SERVICE LETTER September 20-02

This Service Letter is for adding OPTIONAL fuel primers to the engine cylinders.

The affected models are aircraft CH 2000 serial numbers 20-0002 and up.

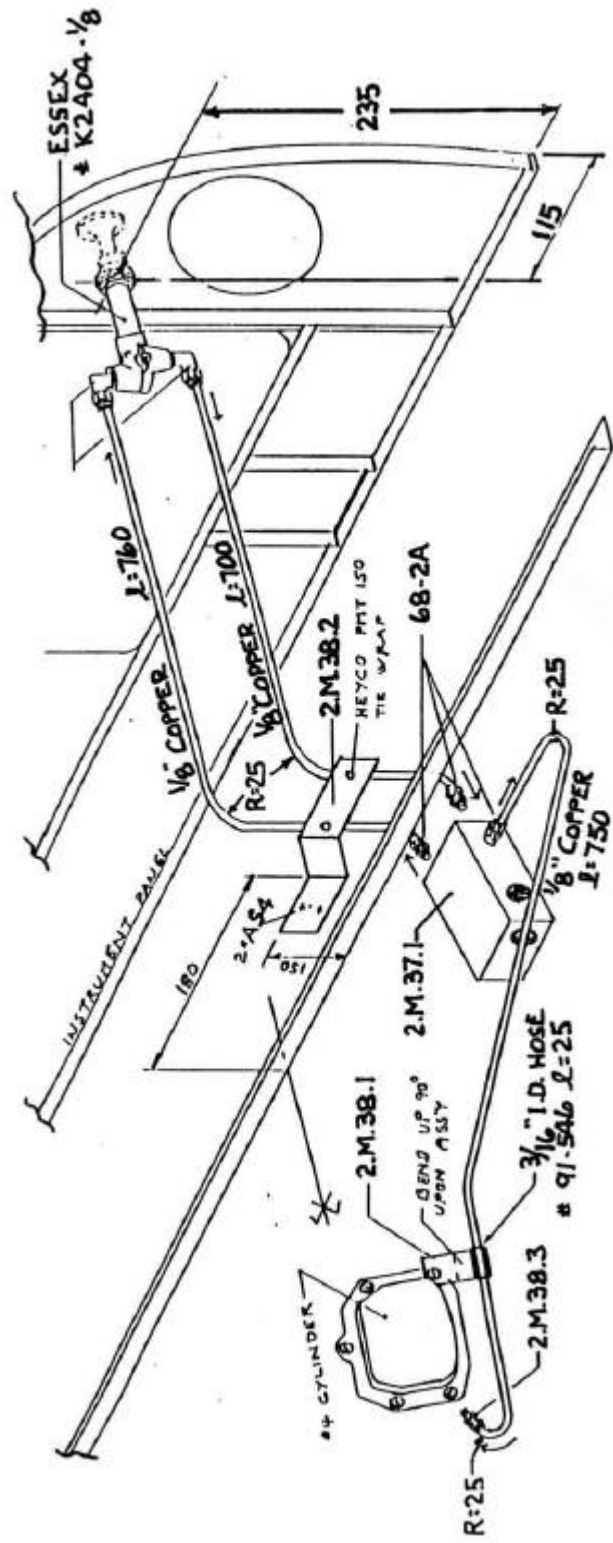
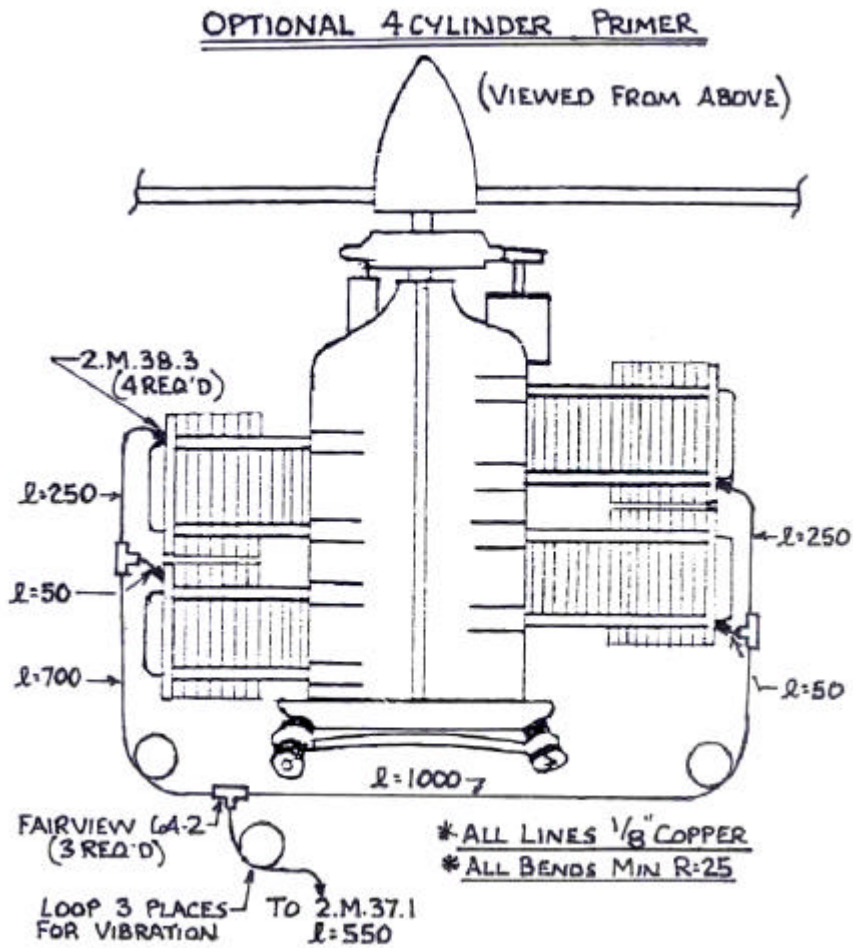
- Install fuel primer Atomizers to cylinders.
- Install the fuel primer 3/16 I.D. rubber hose into the fuel primer brackets
- Install fuel primer brackets 20-M-38-1 to cylinders. Drill holes and trim as required.
- Cut and install 1/8 copper lines to Atomizer and "T" fittings
- Install all above items as per schematics on page two and three.
- Note that the Atomizers and "T" fittings are "brass Compression Fittings" and use standard type 1/8 brass Sleeves (#60-2) for 1/8" copper line.
